**PLANNING APPROVAL (HOLDOVER) &
SUBDIVISION STAFF REPORT****Date: October 6, 2011**

<u>NAME</u>	Bay Bank
<u>SUBDIVISION NAME</u>	East Beltline Subdivision
<u>LOCATION</u>	216 East I-65 Service Road North (East side of East I-65 Service Road North, 425'± North of Old Shell Road)
<u>CITY COUNCIL DISTRICT</u>	District 1
<u>PRESENT ZONING</u>	B-3, Buffer Business District
<u>AREA OF PROPERTY</u>	1 Lot / 0.7± Acre
<u>CONTEMPLATED USE</u>	Planning Approval to allow heavy equipment sales, rental and leasing in a B-3, Community Business District, and Subdivision Approval to create a one-lot subdivision.
<u>TIME SCHEDULE FOR DEVELOPMENT</u>	None given.
<u>ENGINEERING COMMENTS</u>	Engineer needs to confirm that detention is provided for all impervious area added since 1984 and shall also certify that any existing detention pond is adequately sized, functional and stable prior to approval of any building permit. Must comply with all storm water and flood control ordinances. Any work performed in the ALDOT ROW will require an ALDOT ROW permit. Drainage from any dumpster pads cannot discharge to storm sewer; must have connection to sanitary sewer.

SITE PLAN

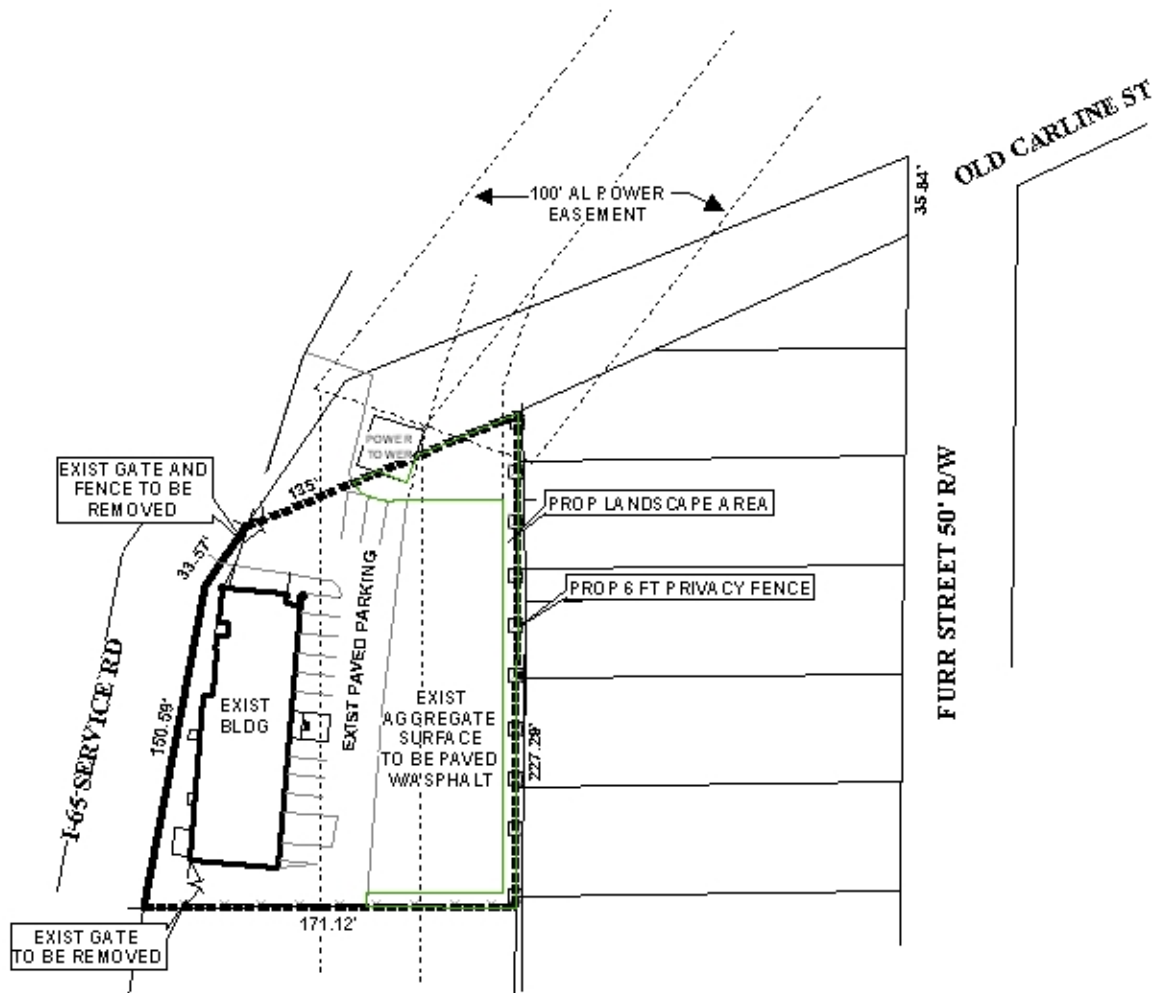
Access to the rear of the site is shown via two sets of gates, neither of which have the required three-vehicle, 51' queuing space out of the public right-of-way. The site plan should be revised to provide the required vehicle queuing space out of the public right-of-way along the I-65 Service Road.

It should be noted that the submitted site plan does not indicate a dumpster location, landscaping and tree planting plan, or buffering along adjacent residential properties. Also, the existing aggregate surface must either be paved with asphalt, concrete, or an approved alternative paving surface or should be removed and landscaped, or a Surface Variance application should be submitted to the Board of Zoning Adjustment.

With regard to the Planning Approval request to allow the equipment sales, rental, and leasing in a B-3 district, the site has been used for a variety of office, retail, wholesale and construction trades, both with and without outside storage. The allowance of equipment sales, rental, and leasing would not be a substantial increase in use over some of the previous uses of the site. Aerial photographs of the site indicate past bleed-over into neighboring properties to the North and East for storage/lay-down areas, portions of which were in R-1, Single-Family Residential districts. The revised site plan and narrative submitted now indicate containment of the proposed use entirely within the existing metes-and-bound parcel containing the building. Compliant buffer fencing along adjacent residential sites to the East is indicated; however, the site plan should be revised to also indicate a minimum 10' vegetative buffer along the rear adjacent to residential properties. Compliant asphalt paving in place of the existing gravel in the rear equipment storage area is also indicated. Non-compliant vehicle queuing areas at the two existing front gates have been eliminated and noncompliant parking in the right-of-way in front has been eliminated via compliant parking planned on-site. The entrance drives at each end of the building are both too narrow to provide two-way access; therefore, the site plan should be revised to indicate a one-way entrance at the South end of the building, and one-way exit at the North end of the building, or revision of the North drive to allow a 24' minimum width

for two-way traffic. The cross-access onto the adjacent property to the North should be eliminated at the Northern drive, also.

The site plan indicates areas for proposed landscaping but no calculations are provided. As there may not be sufficient room in front of the existing building to provide compliant frontage landscaping, and since the Alabama Power Company easement is 92.6' wide, landscaping and tree planting compliance should be coordinated with Urban Forestry. No frontage sidewalk is indicated on the site plan; therefore, the site plan should be revised to indicate a City standard front sidewalk.

- 1) revision of the site plan to indicate a fence along the North property line, as mentioned in the narrative;*
- 2) revision of the site plan to indicate as much compliance as possible with the landscaping and tree planting requirements, to be coordinated with Urban Forestry;*

- 3) revision of the site plan to provide a 10' minimum vegetative buffer along the rear adjacent to residential properties;*
- 4) revision of the site plan to make the Southern drive a one-way entrance;*

- 5) revision of the site plan to make the Northern drive a one-way exit, or revision of that drive to 24' minimum width to allow for two-way traffic;*

- 6) revision of the site plan to eliminate any cross-access to the adjacent property to the North at the Northern drive;*
- 7) revision of the site plan to indicate a compliant City standard sidewalk along the street frontage;*

- 8) subject to the Engineering comments: (Engineer needs to confirm that detention is provided for all impervious area added since 1984 and shall also certify that any existing detention pond is adequately sized, functional and stable prior to approval of any building permit. Must comply with all storm water and flood control ordinances. Any work performed in the ALDOT ROW will require an ALDOT ROW permit. Drainage from any dumpster pads cannot discharge to storm sewer; must have connection to sanitary sewer);*
